Hawthorne/Weatherstone Neighborhood Greenway

3RD PUBLIC MEETING

DECEMBER 8, 2022

Overview of design changes based on feedback

Trail Connection

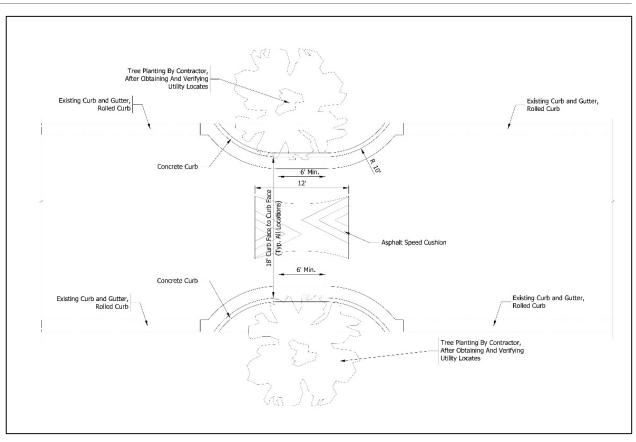
Feedback: concern about motor vehicles using the trail connection from Hawthorne to Weatherstone and concerns about the speed of bicyclists

> Feedback: concerns about lighting, both too much or too little

Feedback: concern about loss of trees

Trail width reduced to 8 feet and curves introduced to reduce speed

>Added physical barrier at Hawthorne to discourage vehicular use

Added one pedestrian scale light

>Worked with City's Urban Forester to minimize tree impacts
